Service News

Suggestion of Maintenance
for Safety and Relief
For the safe use of Sekigahara Product

SSN-016

[SUBJECT] Countermeasure for prevent the accident by misoperation.

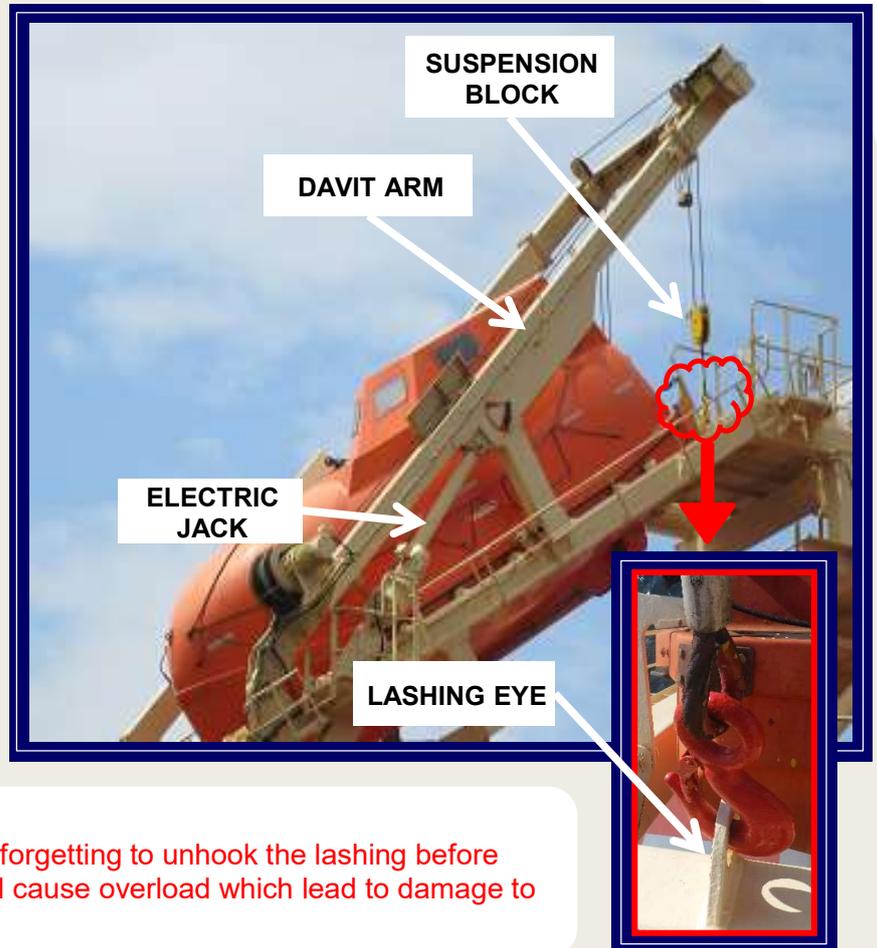
Normal procedure;
After davit arm is brought back to stowing position (stopping position by limit switch), hoisting hooks are hooked directly to lashing eye and giving tension a little bit to the fall wire for eliminating the slack.

⚠ Misoperation;
At the time of next operation, **in case of forgetting to unhook the lashing before hoisting up or luffing up operation, it will cause overload which lead to damage to electric jack.**

It is suggested to use dia 12mm nylon rope between hook and eye plate like a fuse as is shown in the photo. Even if mis-operation happens, it is only a matter of breakage of this rope.

Nylon rope (Cremona rope)
φ12 L=1000

Tie both end rope rings to the eye plates as is shown in the photo. This can avoid loosening or falling of the rope during davit operation.
